Project Summary Fact Sheet

The RTS Project – what changes have we made?

Figure 1: RTS Project Turbine Layout - Comparison with Mod-1 Project

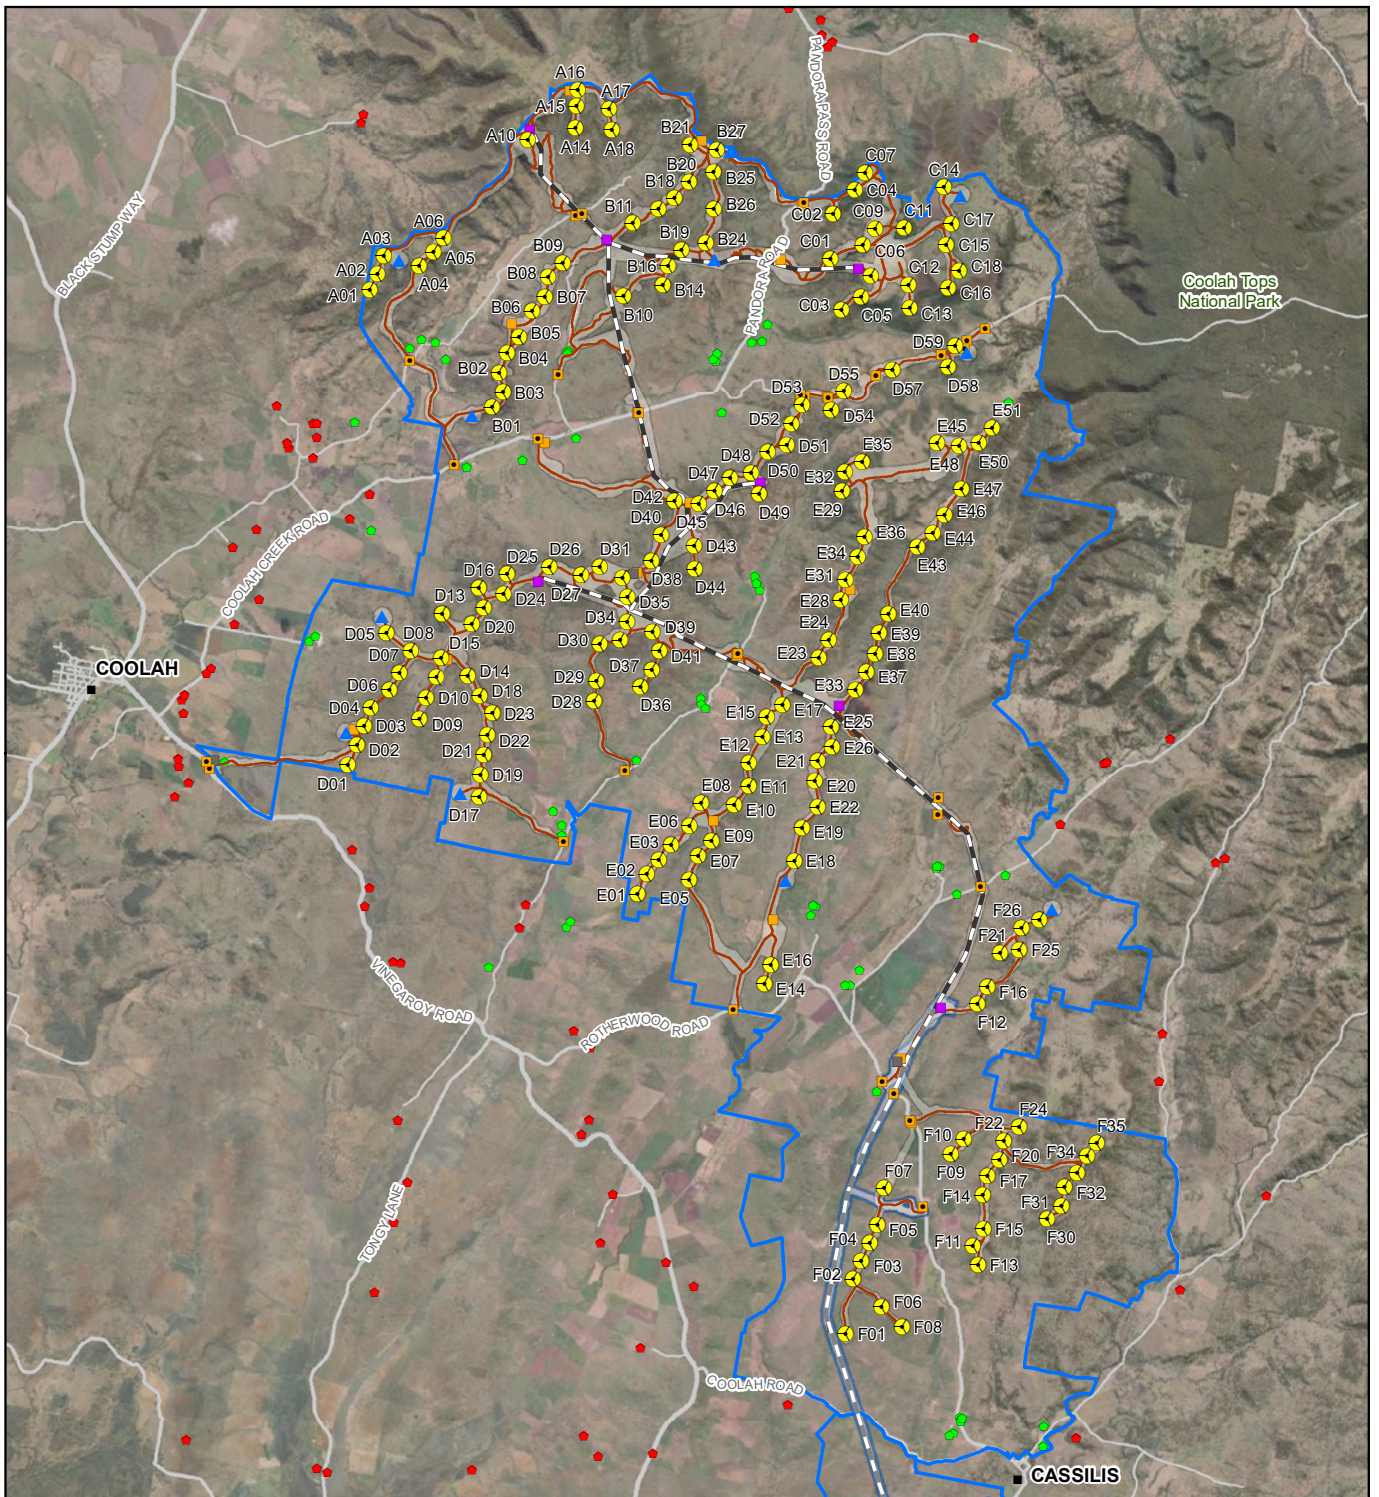
- Further reduction in the number of proposed wind turbines from 220 to 185
- Reduction in the maximum blade tip height from 250 m to 215 m above ground level (AGL).

- We have now selected the Vestas V172 7.2 MW turbine, which has a blade length of 85 m. This equates to a rotor diameter of 172 m. We had previously assumed a rotor diameter of approximately 210 m.

- Removed five turbines that were proposed by the Mod-1 Project in the north east of the site near Coolah Tops National Park, to minimise visibility from Pinnacle Lookout and reduce potential noise impacts within the National Park.

- Amendment to the External Transmission Line alignment to completely avoid a portion of Durrigere State Conservation Area, near Turill.
- Shifted three turbines (D40, D43 and E31) to avoid impacts to a communications link proposed by the NSW Telecommunications Authority (NSW Telco)

- Removed optional locations for various infrastructure, such as duplicate access track site entrances and associated access track alignments, and substation locations.

Figure 2: External Transmission Line (RTS Project)

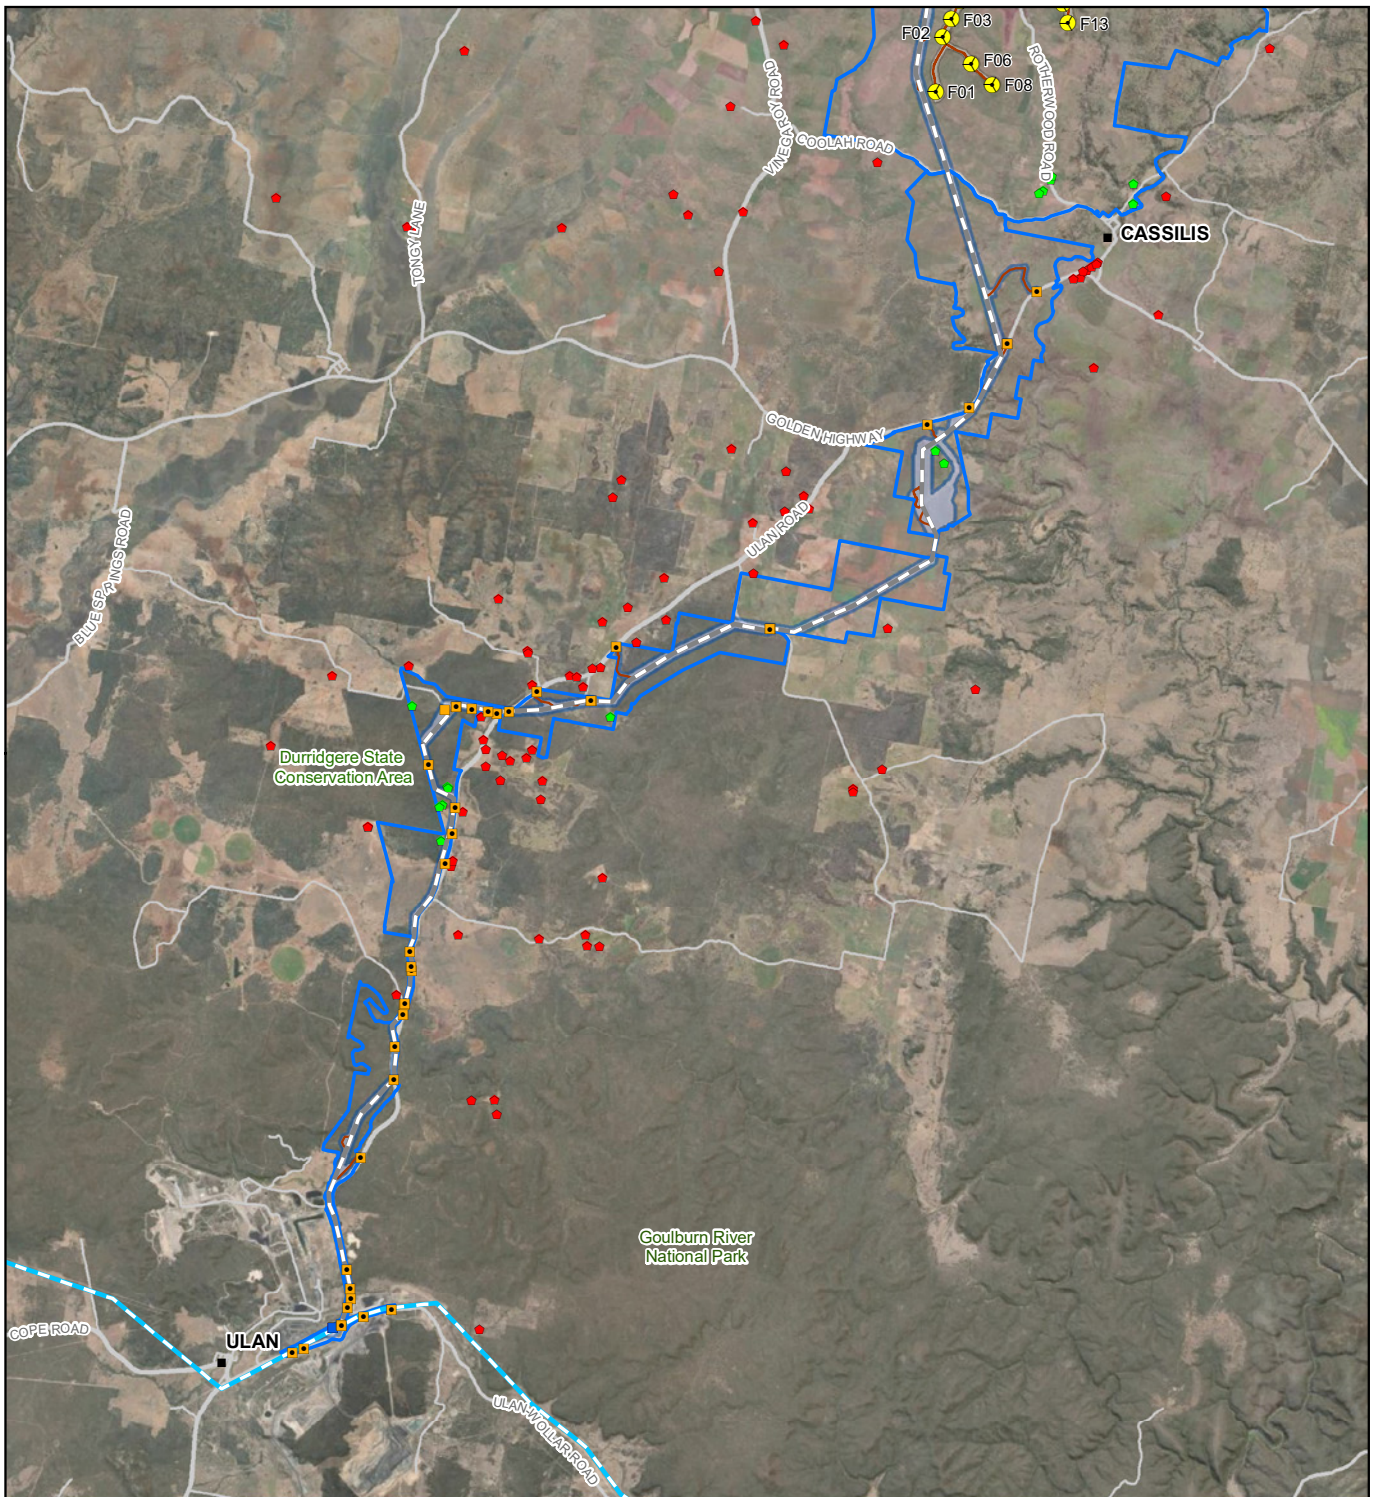
In the event that the Liverpool Range Wind Farm project connects into the CWO REZ Transmission Line, the external transmission line connection down to Ulan proposed by the RTS Project would no longer be required and all associated impacts would no longer apply. Despite this, all potential impacts associated with the entire length of the transmission line down to Ulan have been addressed in RTS Project documentation. This is to ensure that the Project has approval for a transmission line (which connects the Project to the national electricity grid) in the unlikely event that the delivery timeframes for the CWO REZ Transmission Line project do not align.
